737

Service Bulletin

Number: 737-57-1320
Original Issue: October 07, 2016
ATA System: 5700

SUBJECT: WINGS - Trailing Edge - Tank Access Door - Replacement

**FIGURE 4: RIGHT WING - DOUBLER - CAP SEAL NUTPLATES
(SHEET 1 OF 4)**

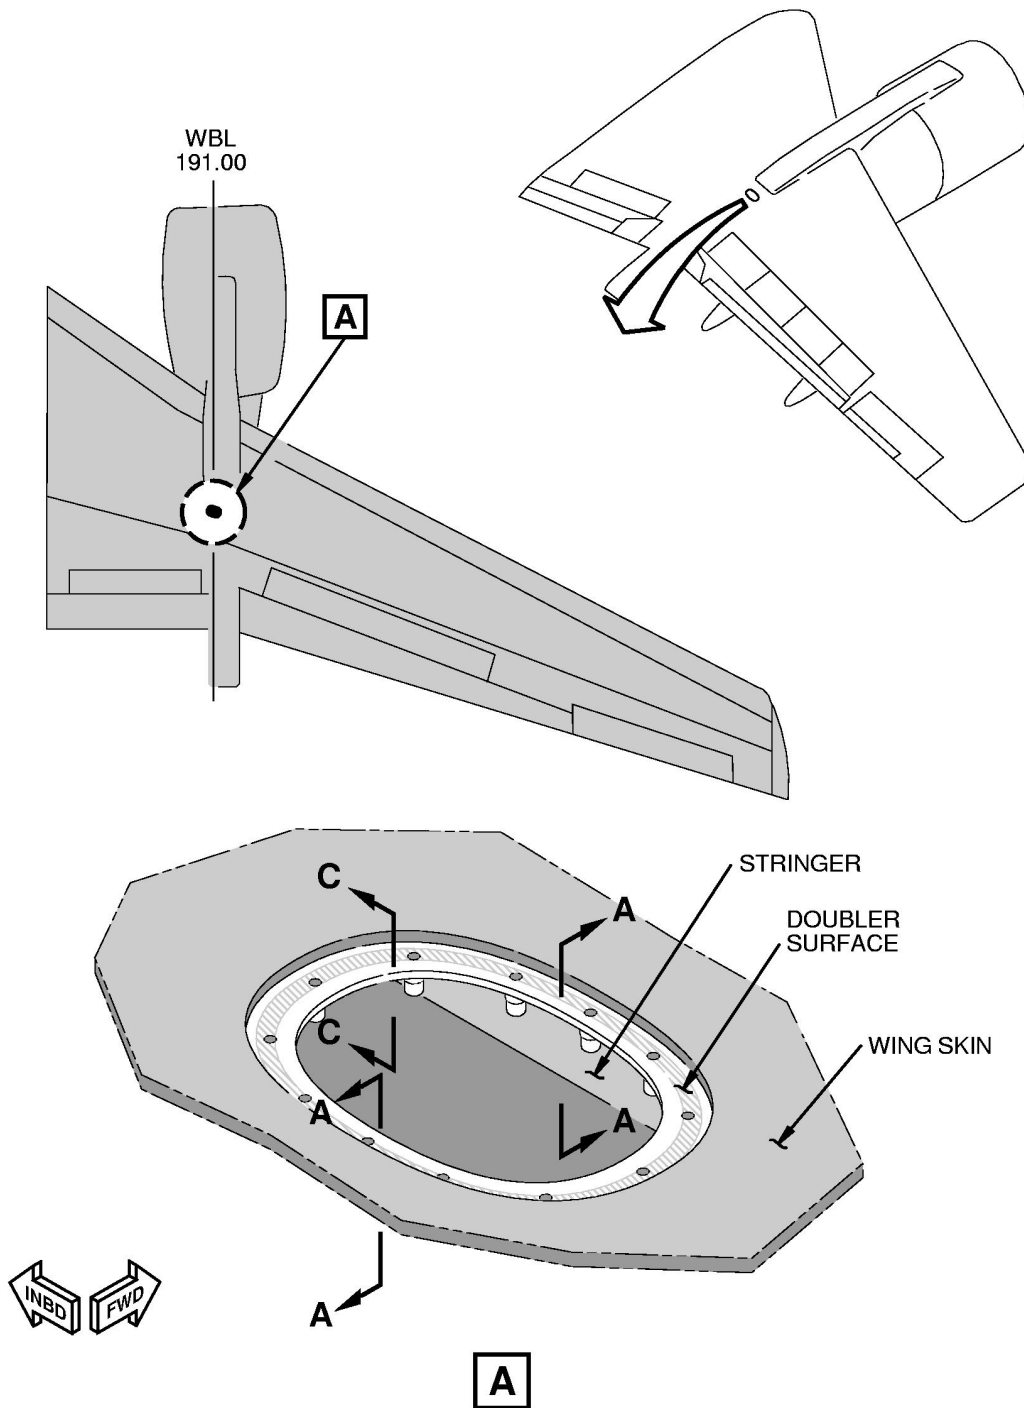
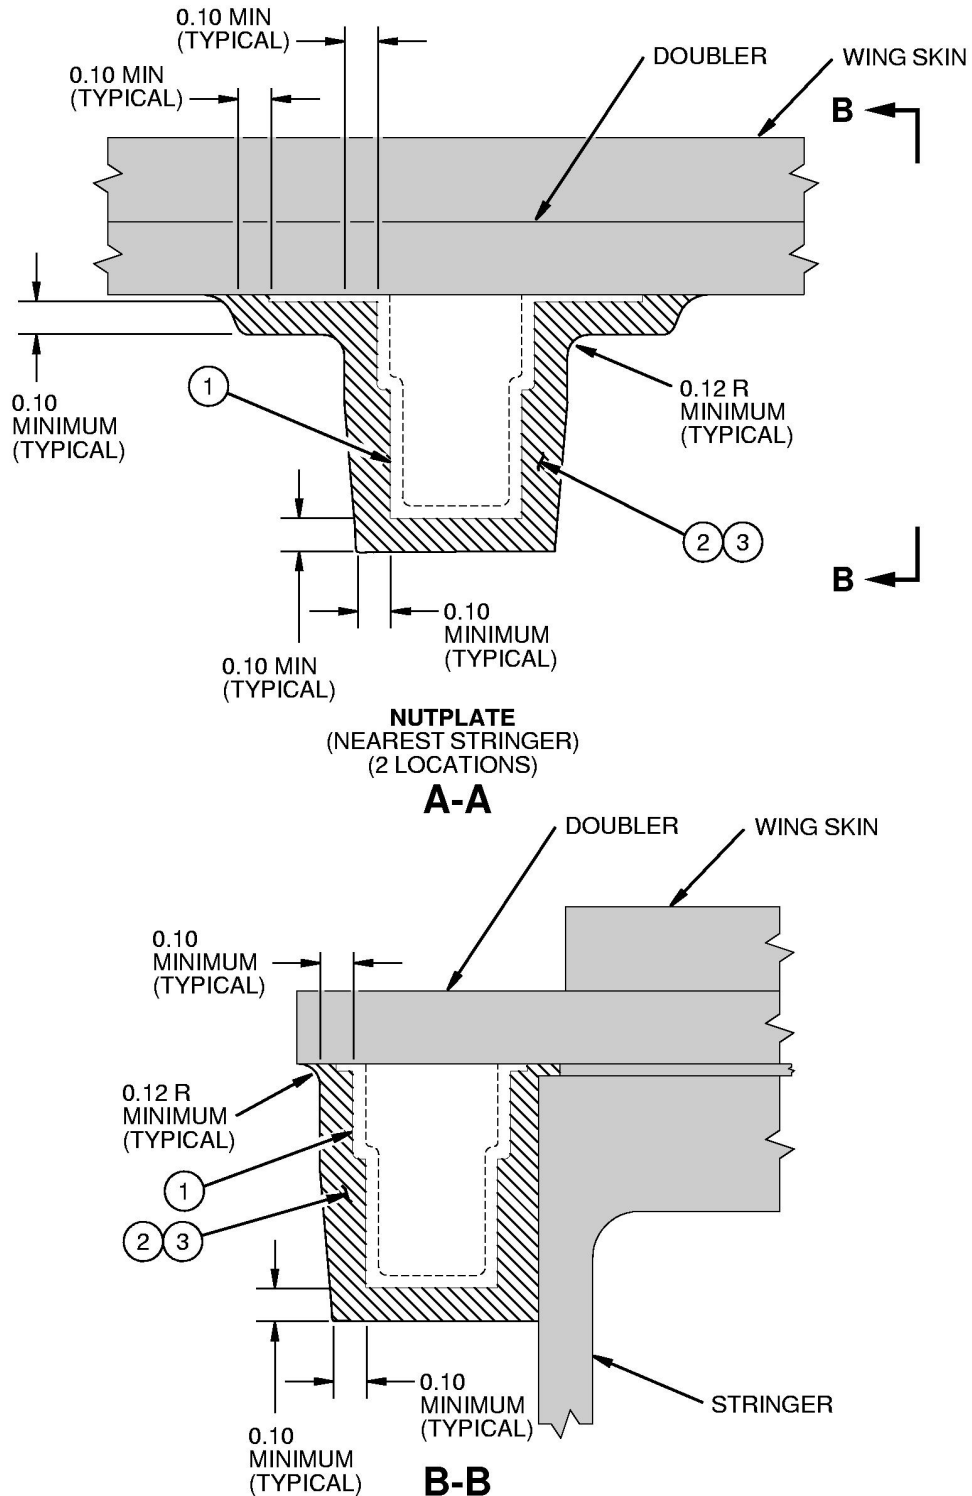
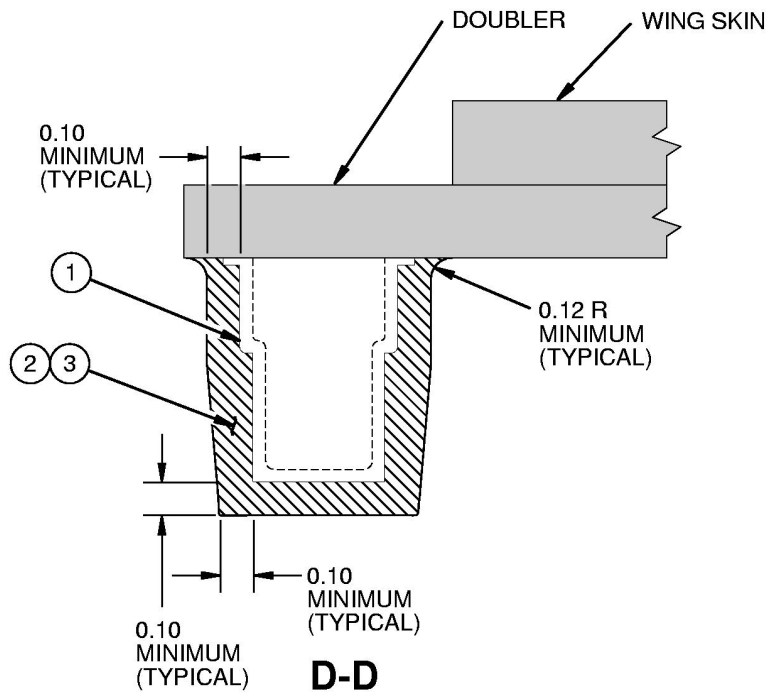
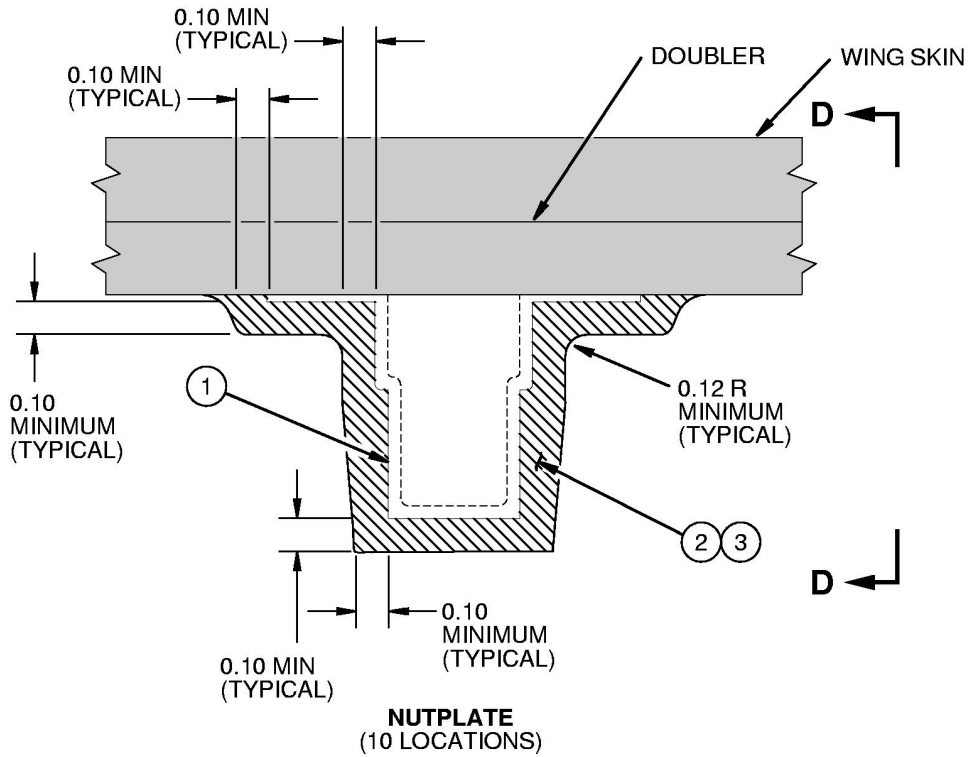
- a. Left Wing - Do the work in accordance with FIGURE 3.
 - b. Right Wing - Do the work in accordance with FIGURE 4
3. RC - Install the new door assemblies at WBL 191.00.
 - a. Left Wing
 - (1) Install the new door assembly 8117L with a wire mesh gasket and bolts in accordance with FIGURE 5.
 - (2) Measure the door assembly -to- wing skin electrical bond in accordance with FIGURE 5.
 - (a) The electrical bond check is complete if the maximum resistance is 0.0025 ohm (2.5 milliohm) or less.
 - (b) If the maximum resistance value is NOT 0.0025 ohm (2.5 milliohm) or less.
 - 1) Temporarily remove the parts that were installed in accordance with FIGURE 5.

| Step | Task | Name | Identification | Qty | More Data |
|--|-------|----------|-------------------|--------|--|
| (b) Move the sealant with a sealant fairing tool to get the minimum dimensions shown in this figure. | | | | | |

FIGURE 5: LEFT WING - INSTALL NEW DOOR ASSEMBLY AND WIRE MESH GASKET, APPLY ENAMEL FINISH, MEASURE ELECTRICAL BOND (SHEET 1 OF 4)

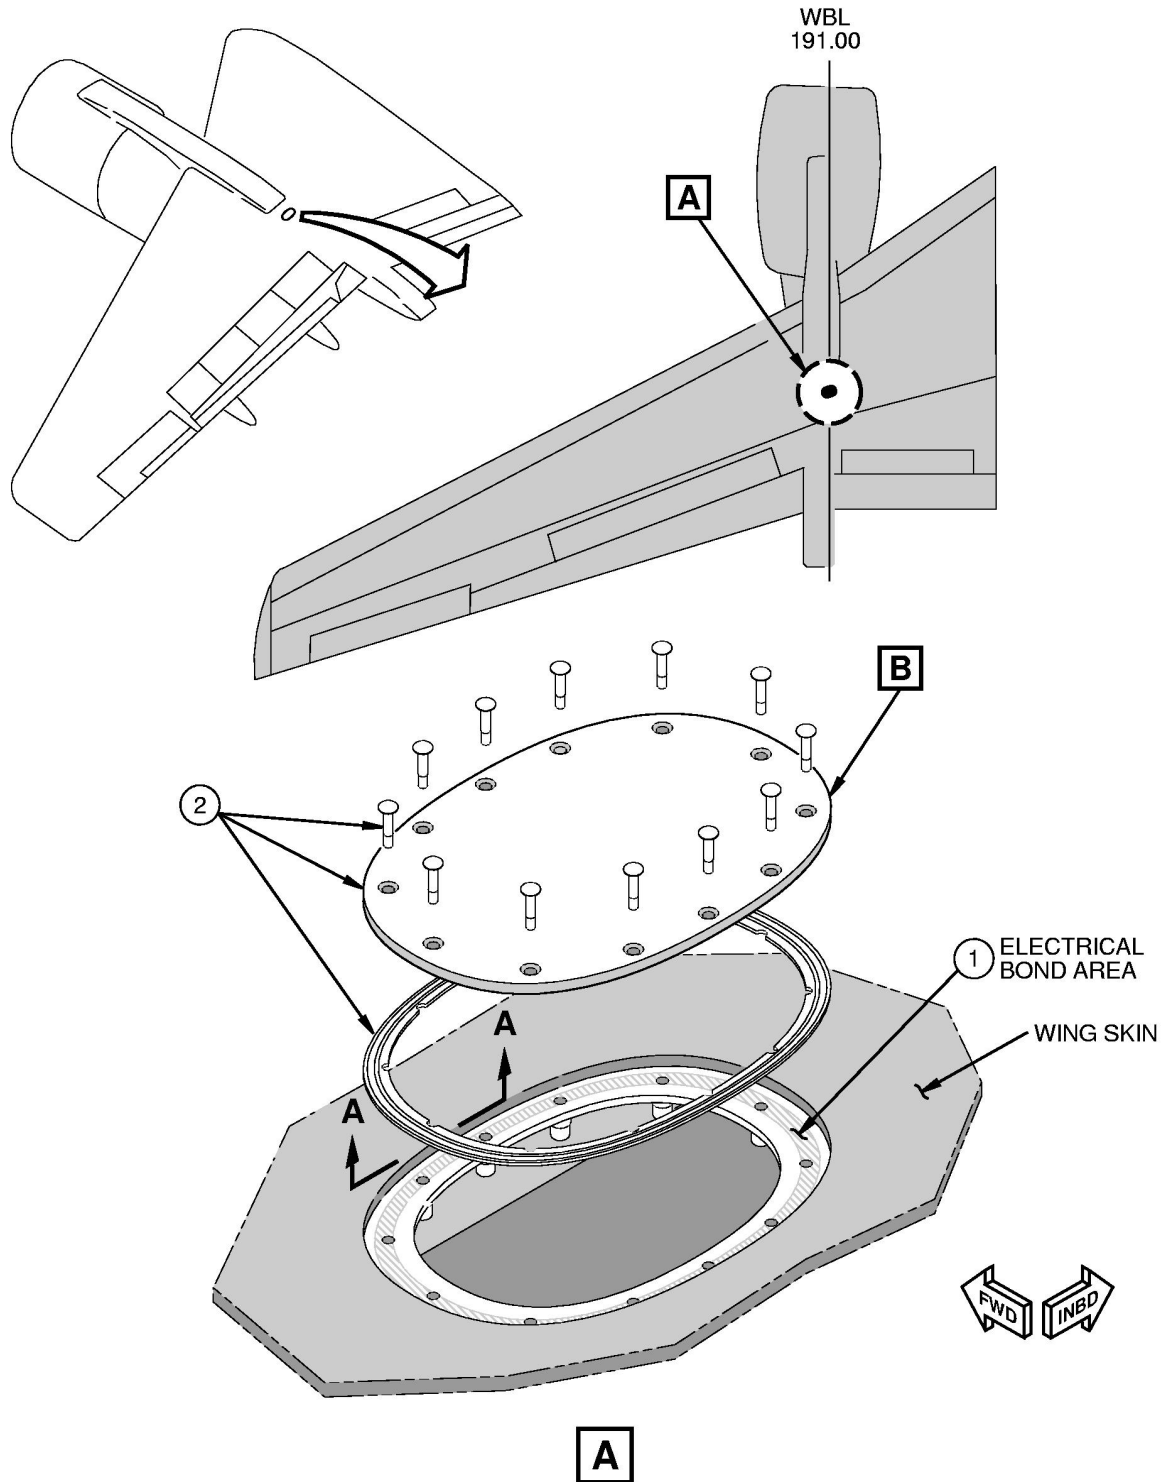
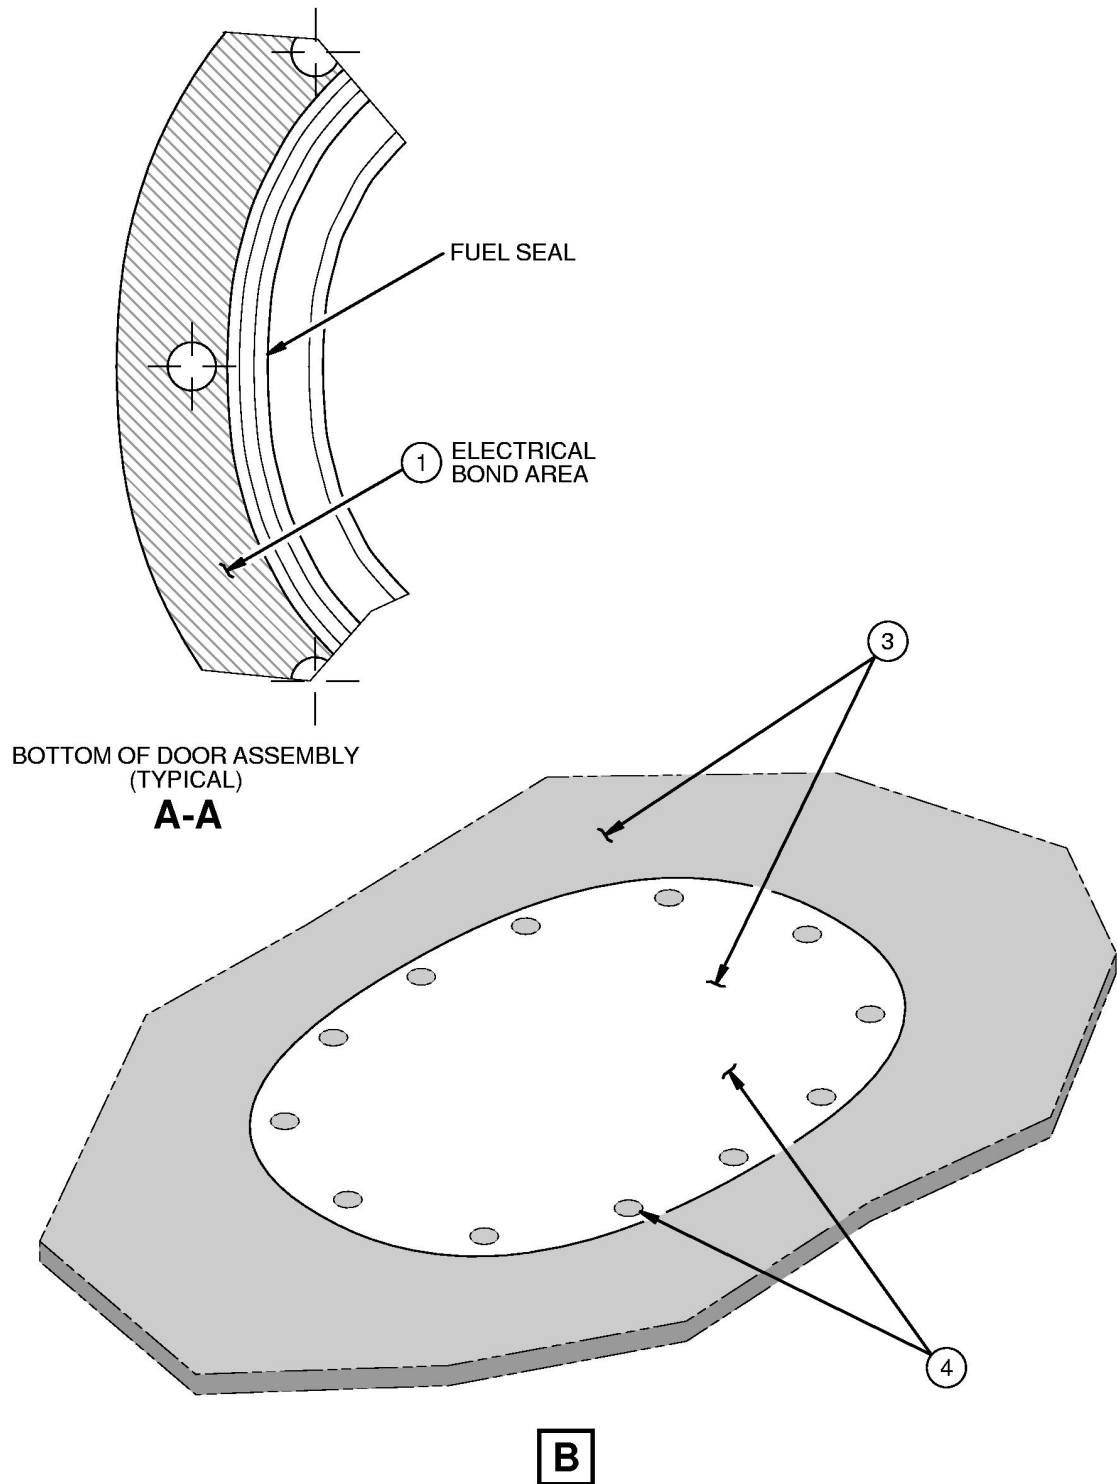
- 2) Make sure the electrical bond area on the doubler surface was prepared correctly in accordance with FIGURE 1.
 - 3) Make sure that the wire mesh gasket is installed correctly to get a sufficient electrical bond at the doubler-to-door assembly interface in accordance with FIGURE 5.

- 4) Install the new door assembly 8117L in accordance with FIGURE 5.
 - 5) Measure the door assembly -to- wing skin electrical bond in accordance with FIGURE 5.

**FIGURE 6: RIGHT WING - INSTALL NEW DOOR ASSEMBLY AND WIRE MESH GASKET, APPLY ENAMEL FINISH, MEASURE ELECTRICAL BOND
(SHEET 2 OF 4)**

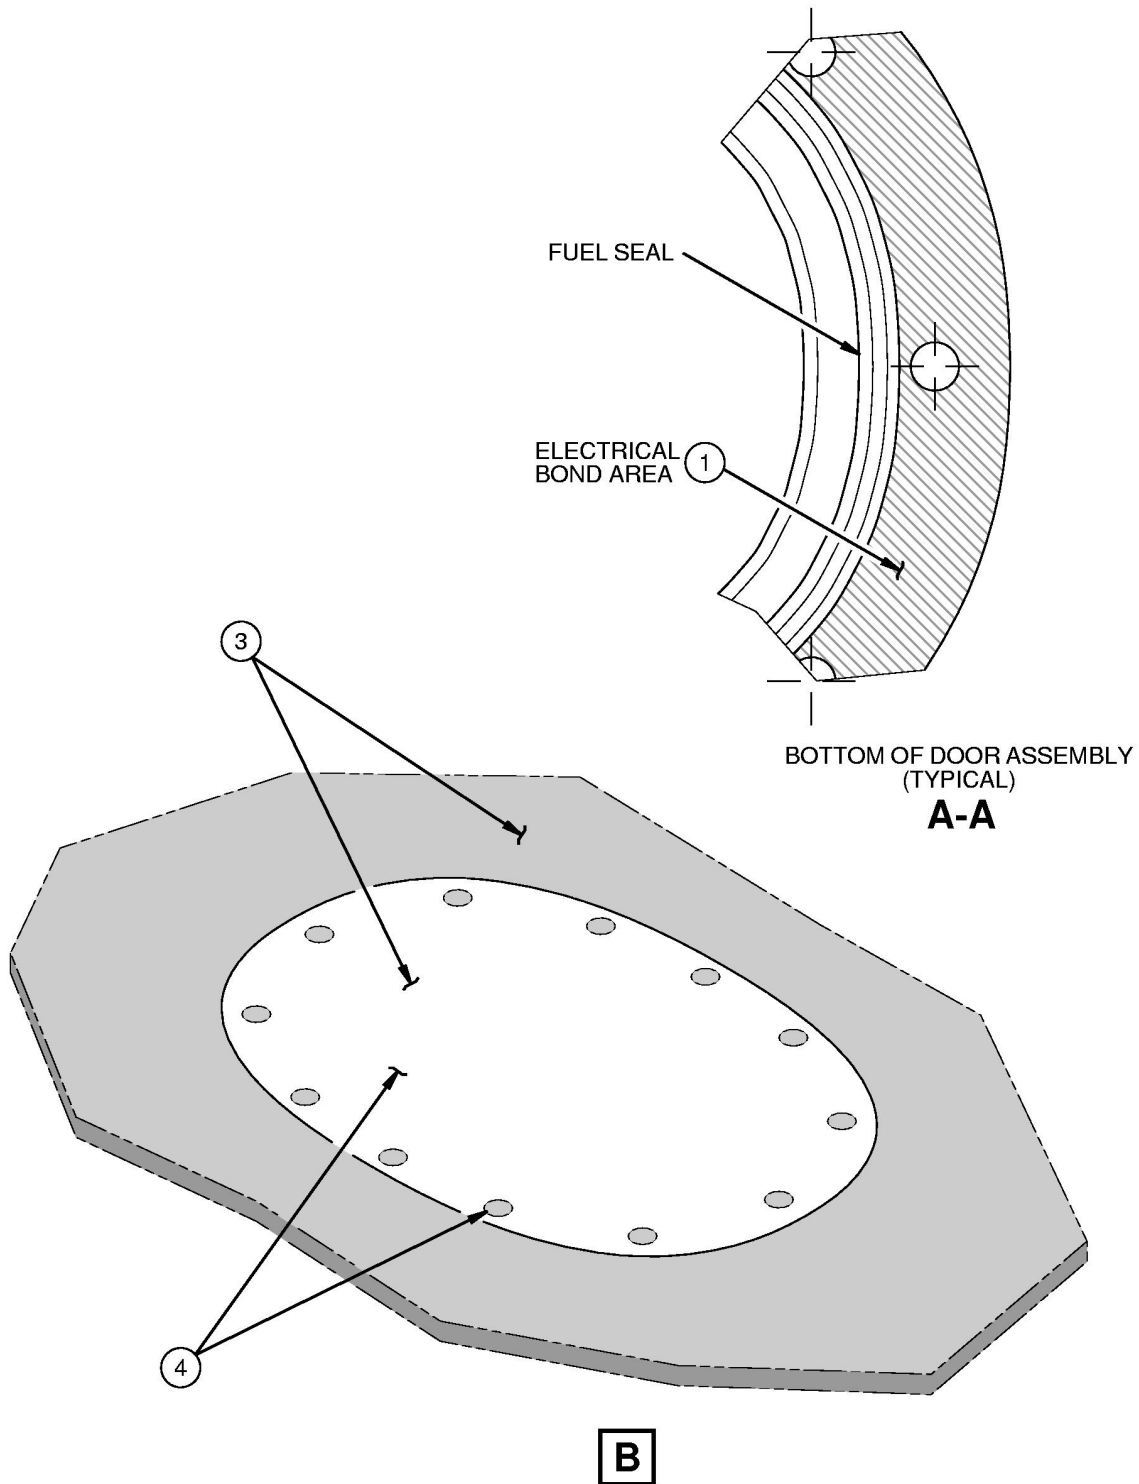
- (3) Apply an enamel finish to the door assembly installation in accordance with FIGURE 5.
- b. Right Wing
- (1) Install the new door assembly 8817R with a wire mesh gasket and bolts in accordance with FIGURE 6.

- (2) Measure the door assembly -to- wing skin electrical bond in accordance with FIGURE 6.
 - (a) The electrical bond check is complete if the maximum resistance is 0.0025 ohm (2.5 milliohm) or less.

- 2) Make sure the electrical bond area on the doubler surface was prepared correctly in accordance with FIGURE 2.
 - 3) Make sure that the wire mesh gasket is installed correctly to get a sufficient electrical bond at the doubler-to-door assembly interface in accordance with FIGURE 6.

- 4) Install the new door assembly 8817R in accordance with FIGURE 6.
 - 5) Measure the door assembly -to- wing skin electrical bond in accordance with FIGURE 6.
